Docket Item #3  
BZA CASE #2008-0027

Board of Zoning Appeals  
October 16, 2008

**ADDRESS:** 116 E. ROSEMONT AVENUE  
**ZONE:** RB, RESIDENTIAL  
**APPLICANT:** RICARDO A. HENDI AND SILVIA BURSTEIN-HENDI, OWNERS

**ISSUE:** Variance to construct a rear open second story deck, reducing the required open space to 461 square feet.

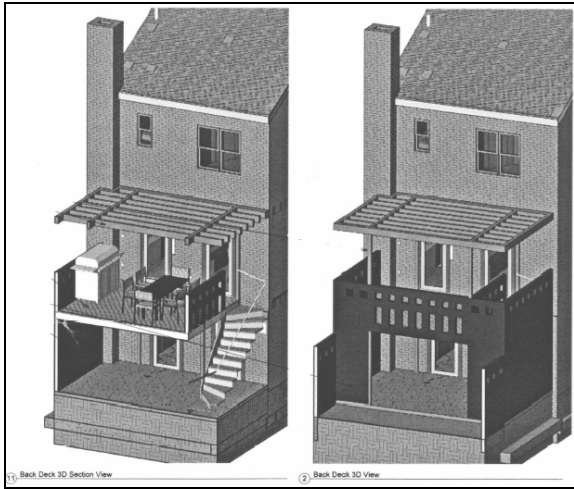
The applicants have revised the rear porch the design in the following manner:

- (1) Lower patio wall and upper level porch wall are replaced with a 6 .00 feet high wood fence along the patio level side yard property lines. No side screening walls at the deck level are proposed.
- (2) Replace solid screen wall on deck with a standard open fence railing.
- (3) Proposed deck matches similar neighboring decks.
- (4) Solid wood panels on the lower level patio facing the rear yard have been deleted.

The porch and second level pergola remain the same height and dimensions as depicted at the September 11, 2008, hearing.
